**Re: Factory Square Property Redevelopment
1, 3, 5, & 7 Fisher Street
Site Plan Modification
LDG Proj. No.: 1899.00**

STORMWATER REPORT
FOR
FACTORY SQUARE
1, 3, 5 & 7 FISHER STREET
FRANKLIN, MASSACHUSETTS

REVISED AUGUST 23, 2023

PROPOSED DRAINAGE

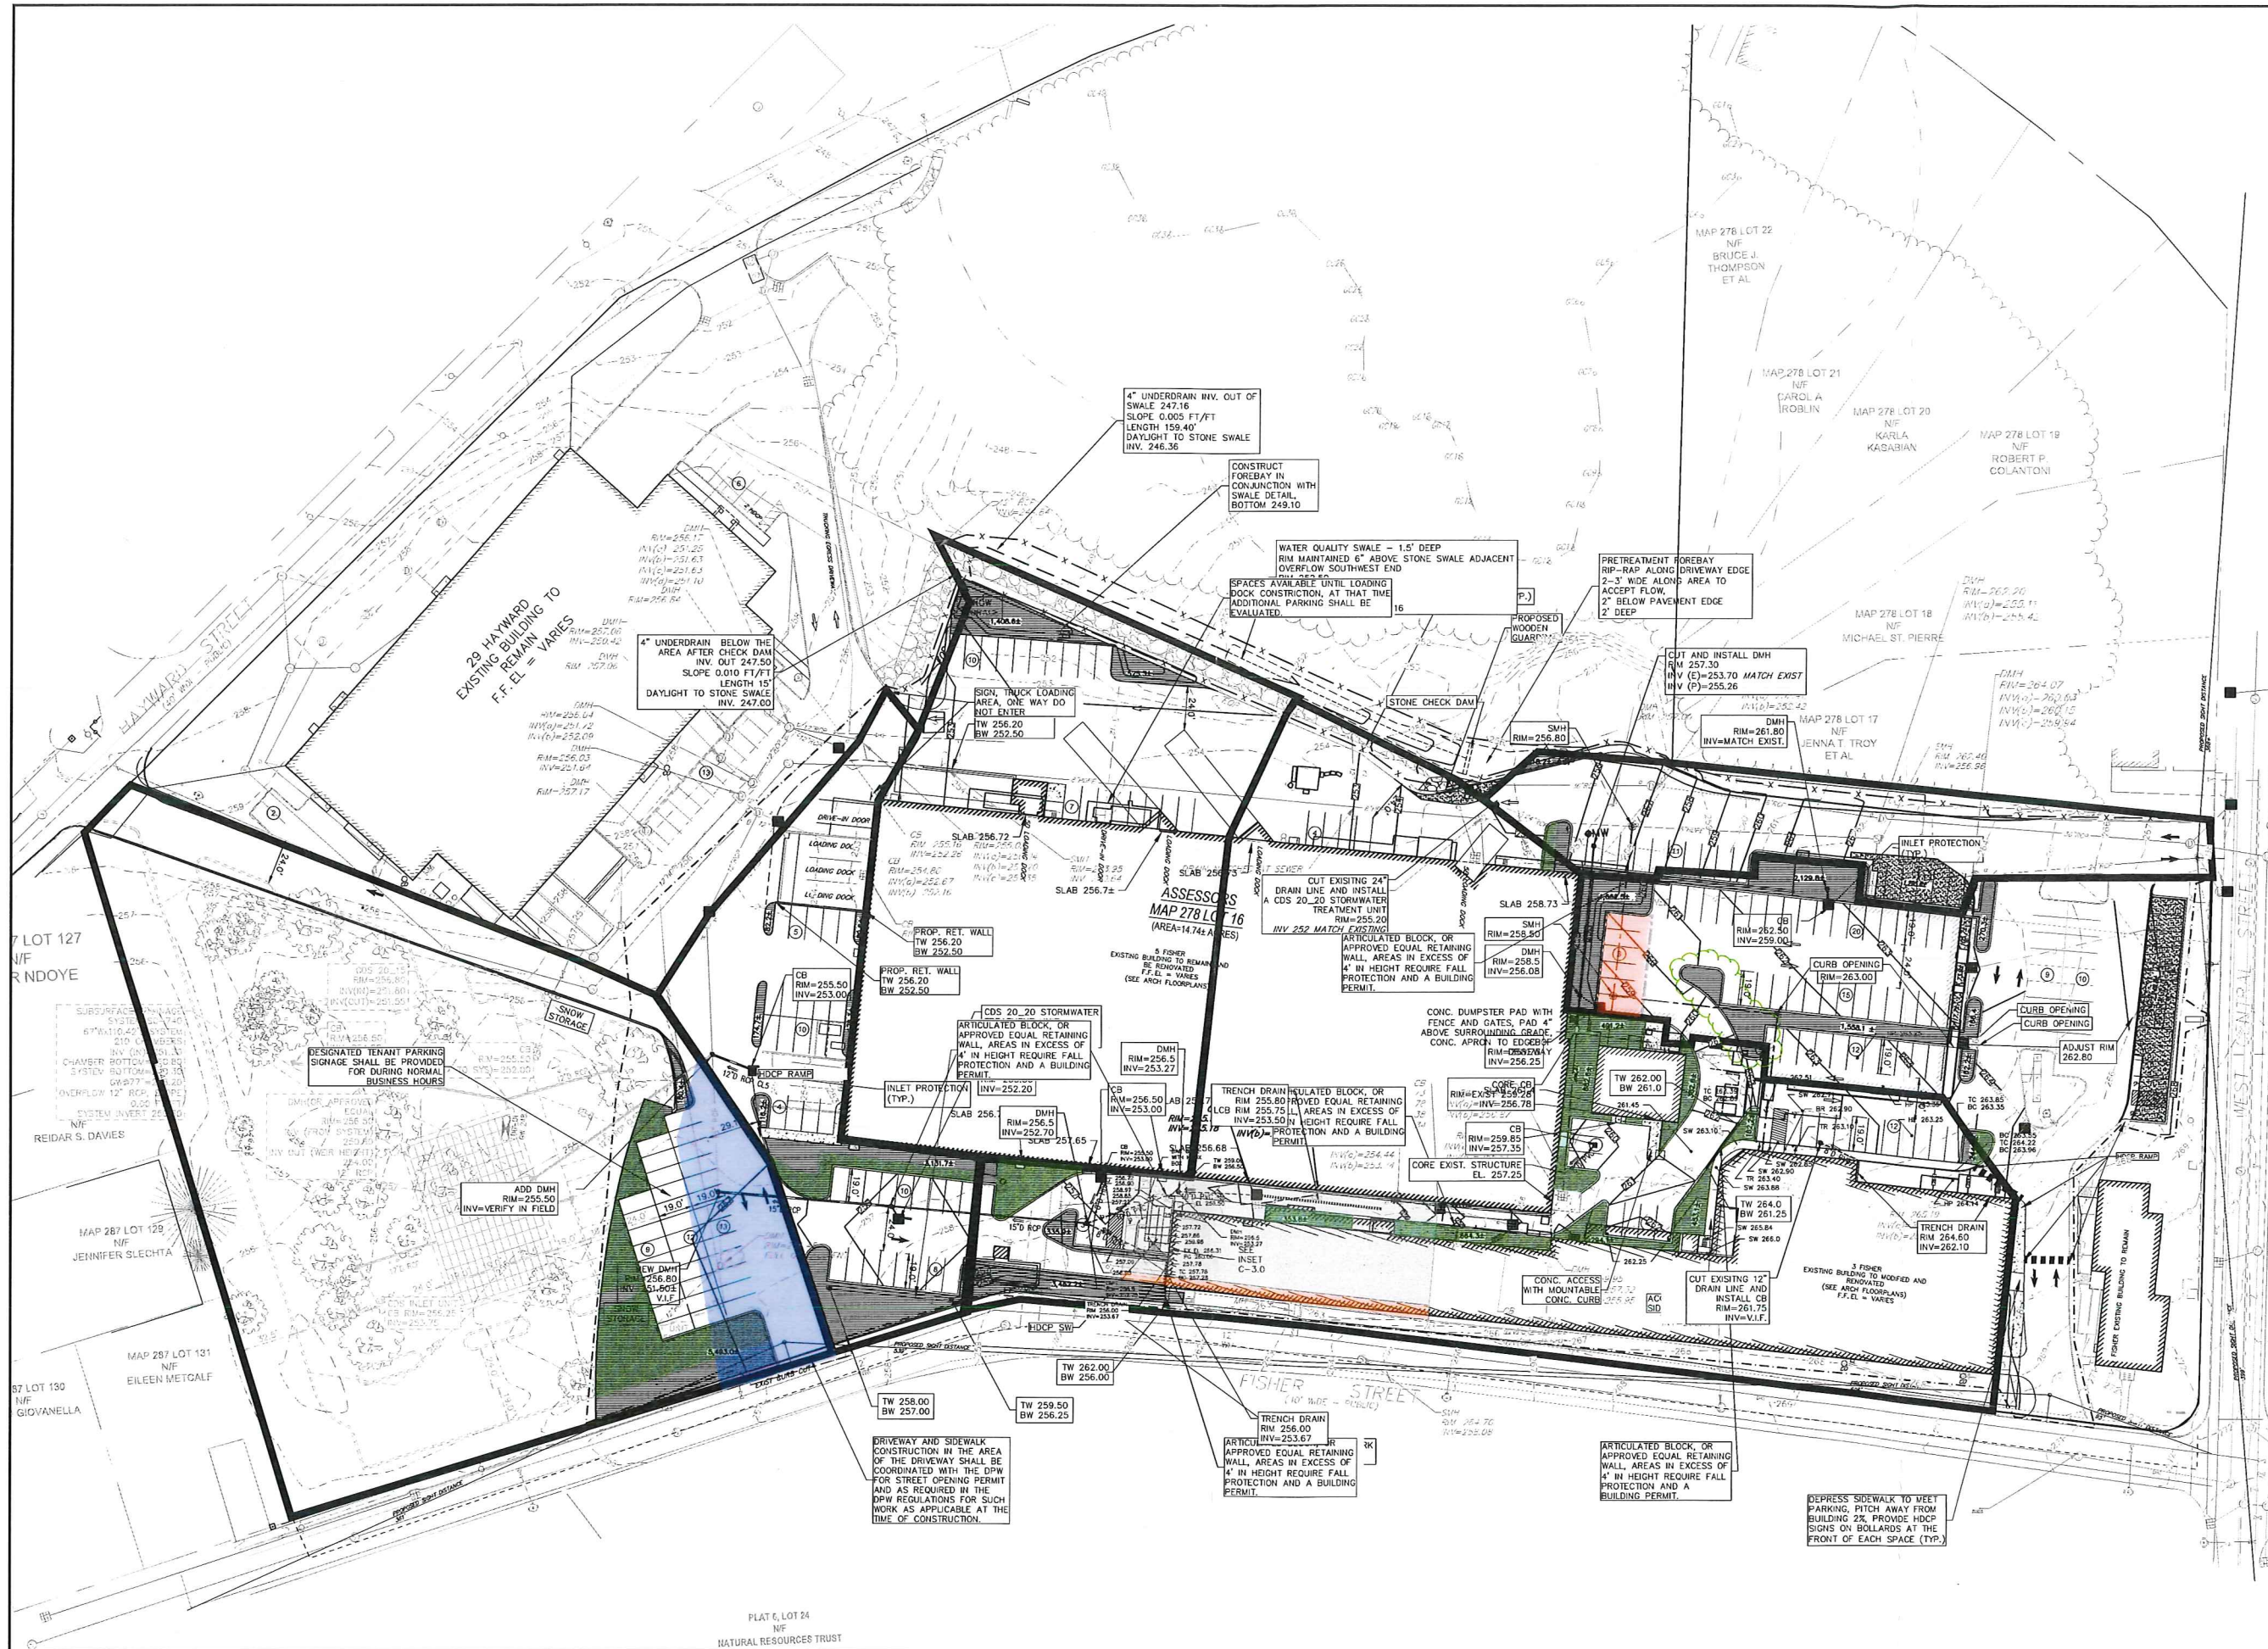
1. *Green hatch is new green space*
2. *Orange hatch is former green space that is now impervious*
3. *Grey hatch is a swap of pavement and building from the approved plan*
4. *Clouded green is a small swap of pavement and green space creating a small net increase in green space in this area.*

5. *Purple is a change is flow path for stormwater*

To address purple in the post condition there is a change of 7,812 s.f. of area which under the approved design was to be captured in the new parking lot drainage system. This flow area will now be captured in the new catch basin at the rear of the building. This flow previously was captured in the same drain line by a catch basin further down.

There is a small portion of existing pavement which drained to the field at the southern end of the property, this portion has been reduced but will continue to flow along this path until such time as the parking is constructed.

Due to the proposed development retaining the future parking area as was fully designed and approved there is no modification to the drainage system. It was felt by the design team and applicant that the increase in green space will be a positive effect on the system, thus allowing the system to maintain the impervious as designed will be a conservative design approach.
